ADDENDUM No. One (1)

IFB NO. 2017-357

Construction, Bridge: County Road 613 over Groves Creek

**November 10, 2017
ADDENDUM NO. 1**

TYPICAL SECTION, DETAILS & QUANTITIES

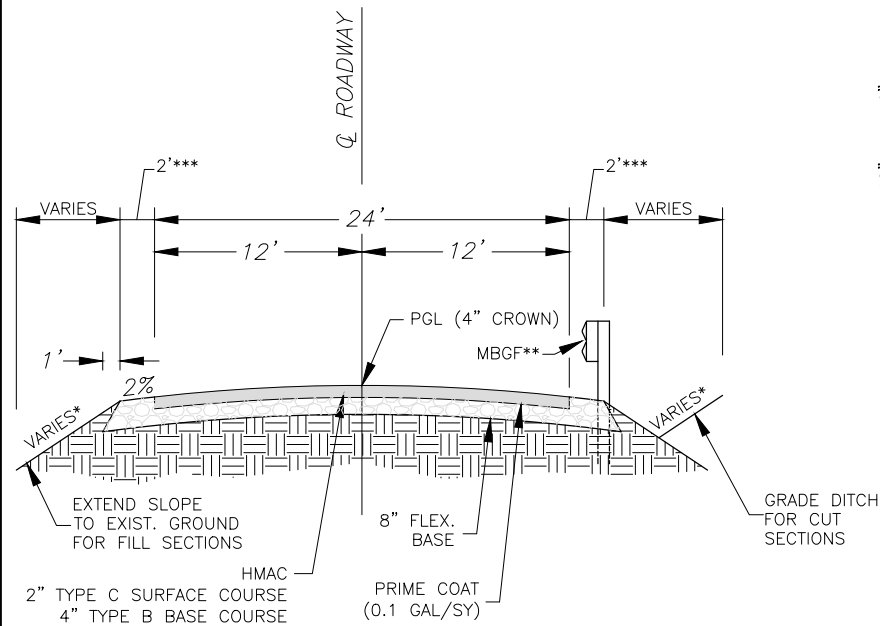
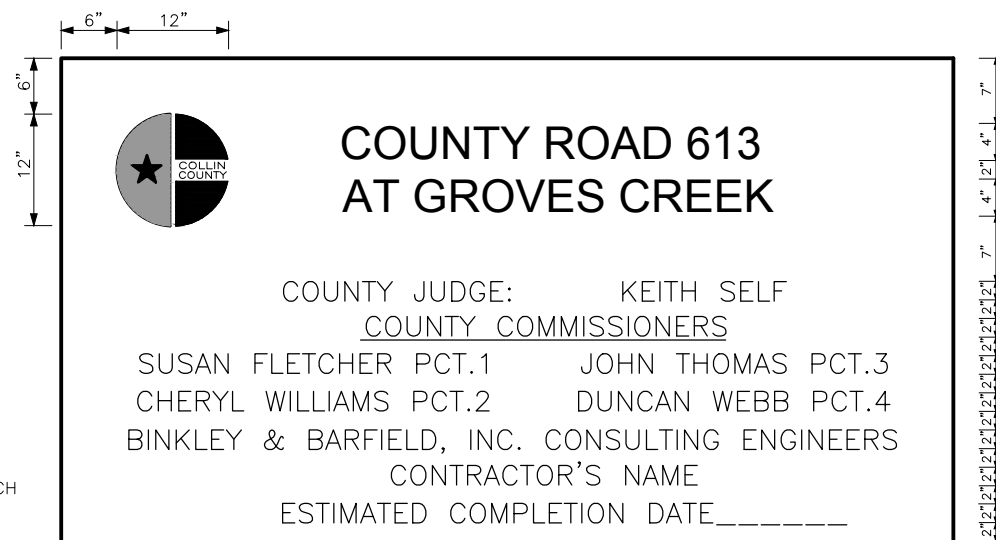
- **Replace Construction Plans, Sheet 04, Typical Section, Details & Quantities with attached Sheet 04**
 - Updated listing of County Commissioners on Project Sign detail

- 4" Type A Base Course is revised to 4" Type B Base Course
- **Replace Bid Proposal Sheet 2 of 8 with attached Sheet 2 of 8**
 - Bid item description for Bid Item 9: Prime Coat (MC-30) is revised to **Prime Coat (AE-P)**.
